ENGINE - H.P. COMPRESSOR - INTRODUCTION OF SCALLOPED HEAT SHIELD RETAINER - STAGE 7
BOROSCOPE POSITION - CATEGORY CODE 6 - MOD.ENG-72-0033

V2500-ENG-72-0033

Rework of H.P. compressor stage 7 rear heatshield retainer
Fig.1

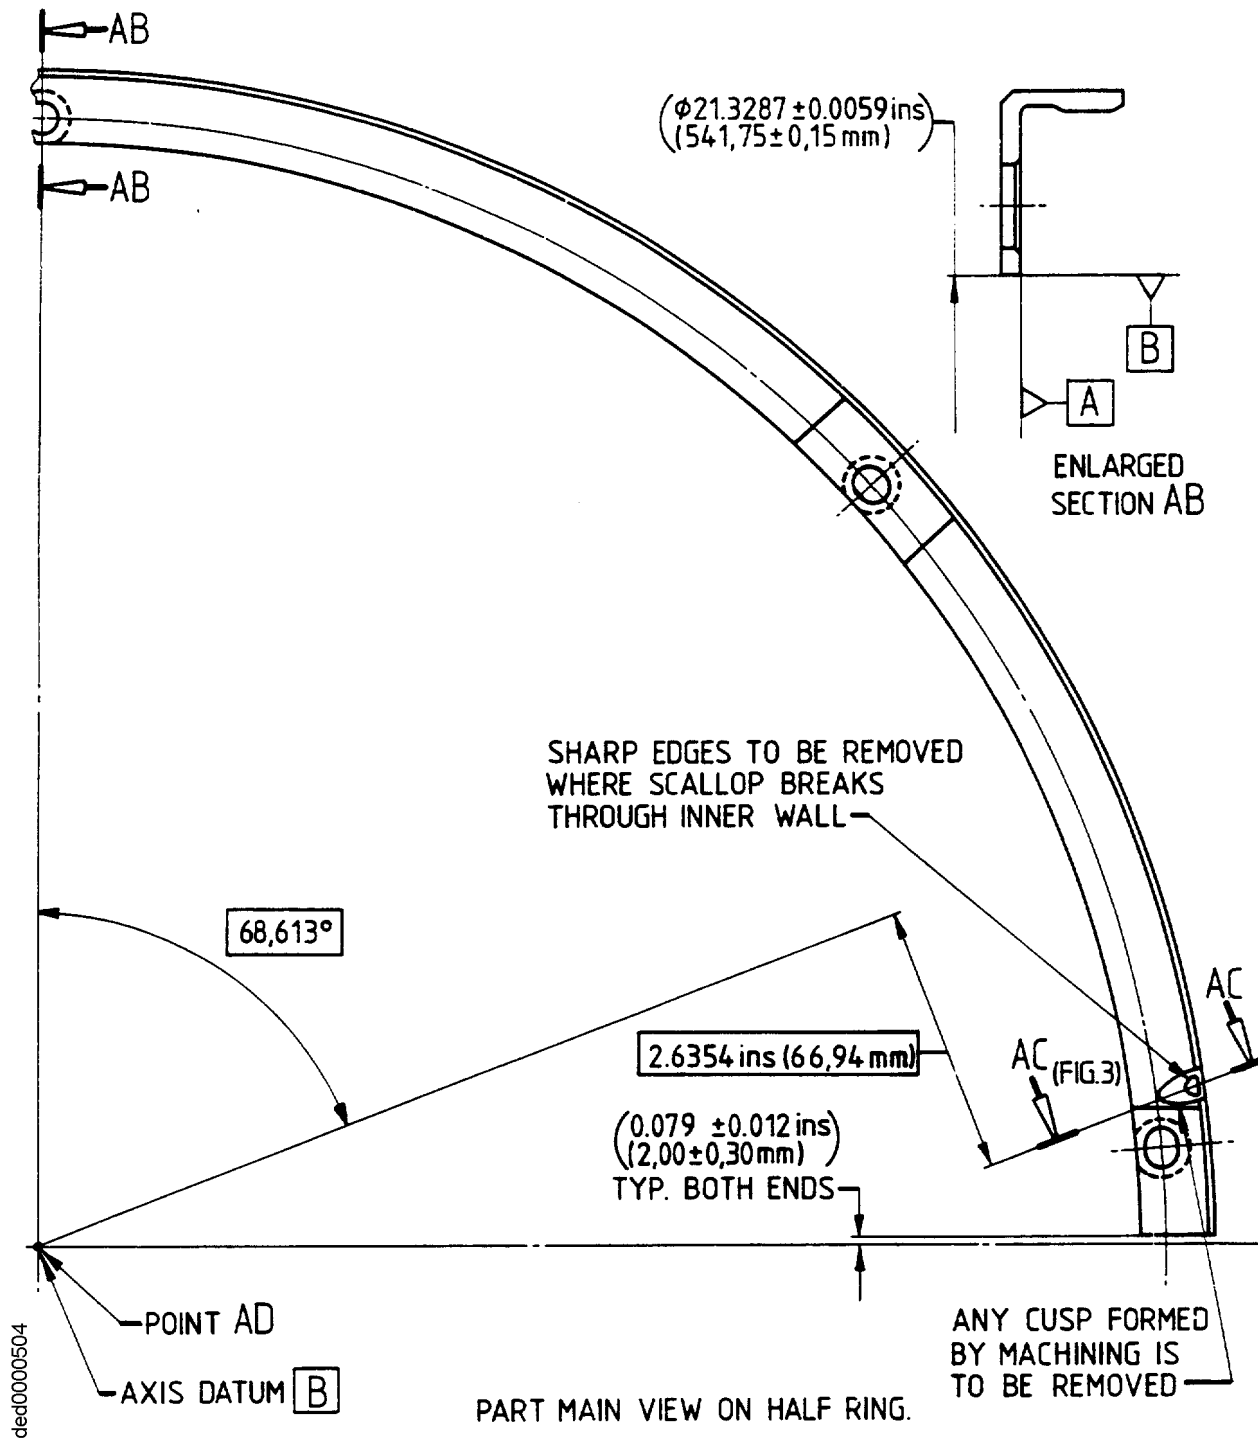
Examination during audit strip, revealed a foul on the stage 7 rear heat shield retaining half ring after difficulties were experienced in carrying out a boroscope inspection. An appraisal of the tolerances on the relevant components revealed that it is possible to have a clearance to interference situation.

- (1) A new H.P. compressor stage 7 rear heatshield is introduced
- (2) The changes introduced by this Service Bulletin are as follows:
 - (a) An additional scallop is machined, adjacent to the boroscope access, at the same compound angle as the boroscope, the size is such that it breaks through the half ring and produces a small leakage hole. Any sharp corners produced by break through to be removed by hand dressing. For commonality and to prevent interchangeability problems both half rings to be the same.
 - (b) Existing H.P. compressor stage 7 rear heatshield retainers can be reworked, see Fig.1 to 3.

DIMENSIONS IN INCHES(MILLIMETRES)

MACHINE WHERE SHOWN ✓

REMOVE THE SHARP EDGES 0.012 ± 0.008 ins($0,30 \pm 0,20$ mm)

MACHINED SURFACE FINISH TO BE 125 MICROINCHES (3,2 MICROMETERS)

AFTER REWORKING,MAKE GOOD ALL DAMAGE TO ENAMEL AS GIVEN IN TEXT.

EXISTING IDENTITY MARKINGS TO BE CANCELLED AND NEW IDENTITY MARKINGS
TO BE ADDED ADJACENT AS GIVEN IN TEXT.

THE PART NUMBER TO BE FOLLOWED BY THE LETTERS 'ASSY.'
